REVIEW COMMENTS

FILE #SPR-96-164

TITLE HEADING: Mike's Auto

LOCATION: 2559 Highway 6 & 50

Site Plan and Utility Composite
Mike's Auto
Highway 6&50
Grand Junction, CO. 81505

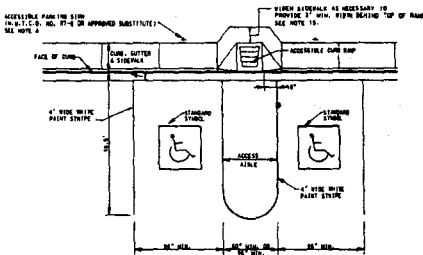
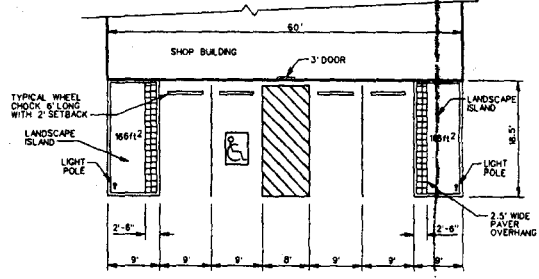
1. It appears that the parking provided does not meet the Zoning and Development Code (ZDC) requirement. Based on your site plan drawing the required parking is as follows:

- a. Office (1 space per 300 sq. ft.): 900 sq. ft. (proposed) X 1 space/300 sq. ft. = 3 spaces
- b. Service bay (2 spaces per service bay): 1 service bay X 2 spaces/service bay = 2 spaces

Total parking required: 5 spaces

Total spaces proposed: 4 spaces

Please revise as required.
